SERVICE BULLETIN

APPLICABILITY: 2019-23MY Ascent

SUBJECT: Power Rear Gate (PRG) Service Procedures

Bulletin Number: 12-251-23; Date: 11/09/23 Page 1 of 2

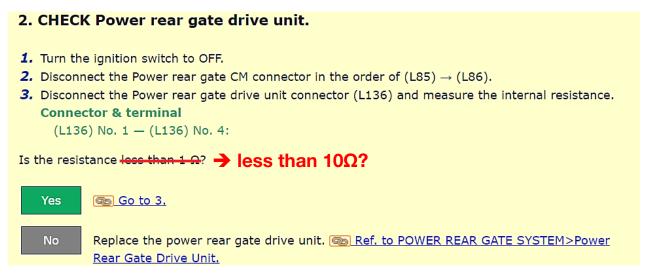
STEP 5: CAREFULLY (slowly) close the gate manually to the full latched position and the "Rear Gate Pos Init Flag" data monitor reads "**ON**."

Pulse-cour	nt 2	0	Count	0	0	0
Rear Gate	Pos Init Flag	ON	←	-	-	-
PRG State	2	Full Close		-	-	-
